## Product Change Notice (PCN)

PCN Number: **PCN-0450975R-01**

Product(s) Affected: SJ1-3523N, SJ1-3524N, SJ1-3525N

F-723-001

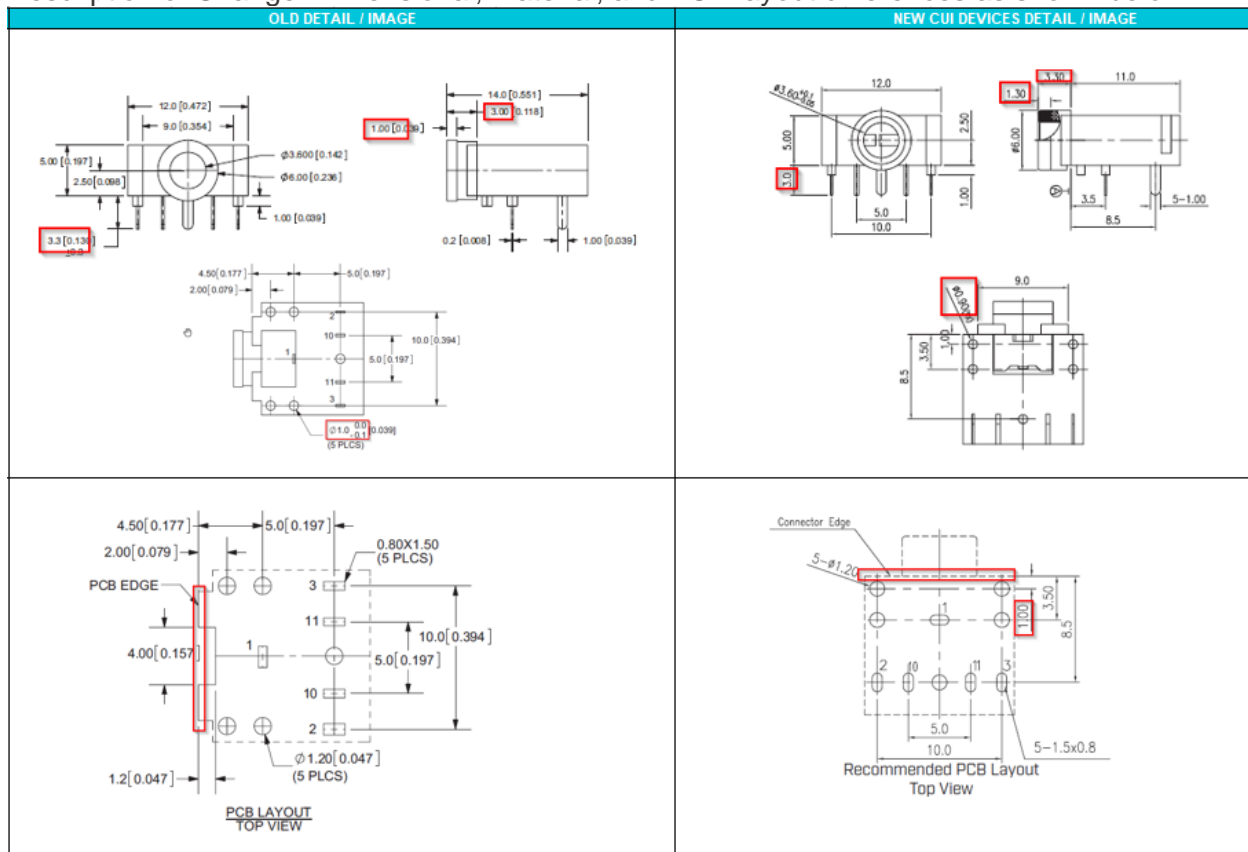
Description of Change: Dimensional, material, and PCB layout differences as shown below:

MATERIAL	PLATING
terminal 1	copper alloy	silver
terminal 2	copper alloy	silver
terminal 3	copper alloy	silver
terminal 10	brass	silver
terminal 11	brass	silver
bushing	brass	nickel
plastic	PBT

DESCRIPTION	MATERIAL	PLATING/COLOR
terminal 1	copper alloy t=0.20	silver over nickel
terminal 2	stainless steel t=0.20	silver over nickel
terminal 3	stainless steel t=0.20	silver over nickel
terminal 10	brass t=0.40	silver over nickel
terminal 11	brass t=0.40	silver over nickel
bushing	brass	nickel
housing	PBT (UL94V-0)	black
